Access Compliance Report Public Rights-of-Way (Curb Ramps)

Intersection ID: 13696Main Street: S_KINGS_DRCross Street: E_3RD_STLocation: WADA ID: 9C636942702BRamp Type: PerpDiagInitial Pass/Fail: FailOverall Compliance: NoSeverity Score: 10

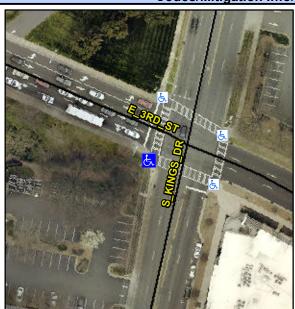
PROW/ADA:
Not Found, R304.5.1

Field Measurements/Component Compliance					
Comp	liance Description	Data	Comp	liance Description	Data
N/A	Ramp Length (in)	57.0	Yes	Ramp Slope (%)	6.6
No	Ramp Width (in)	47.0	Yes	Ramp XSlope (%)	3.3
N/A	Flare Type LT	N/A	N/A	Flare Type RT	N/A
N/A	Flare Slope LT (%)	N/A	N/A	Flare Slope RT (%)	N/A
N/A	Flare Traversable LT?	N/A	N/A	Flare Traversable RT?	N/A
N/A	Landing Length (in)	N/A	N/A	DWS Provided?	N/A
N/A	Landing Width (in)	N/A	N/A	DWS Contrast?	N/A
N/A	Landing Slope (%)	N/A	N/A	DWS Length (in)	N/A
N/A	Landing X Slope (%)	N/A	N/A	DWS Full Width?	N/A
N/A	Landing Curb? (Y/N)	N/A	N/A	DWS Offset (in)	N/A
N/A	Shared Landing?	N/A			
N/A	Gutter Ponding?	N/A	N/A	Gutter Slope (%)	N/A
N/A	Gutter Lip Ht (in)	N/A	N/A	Gutter X Slope (%)	N/A
N/A	Painted X Walk1?	Yes	N/A	Painted X Walk2?	Yes
	X Walk 1 Direction	To SE		X Walk 2 Direction	To NE
N/A	X Walk 1 Width (in)	95.0	N/A	X Walk 2 Width (in)	95.0
	X Walk 1 Slope (%)	5.5		X Walk 2 Slope (%)	3.3

X Walk 1 X Slope (%)	2.3		X Walk 2 X Slope (%)	3.8
N/A	Ramp inside XWalk1?	Yes	N/A	Ramp inside XWalk2?	Yes
	Road Slope (%)	5.2	N/A	Clear Space?	N/A
	Road X Slope (%)	2.9	N/A	Clear Space to XWalk (in)	N/A
N/A	Any Obstructions?	N/A	N/A	Storm Grate/Utility Hazard?	N/A
	Obstruction Type			Storm Grate/Utility Type	
		N/A			N/A
			Yes	Surface Condition? (G/P)	Good

Remove & Replace Curb Ramp With
Two New Directional Ramps or
Equivalent.
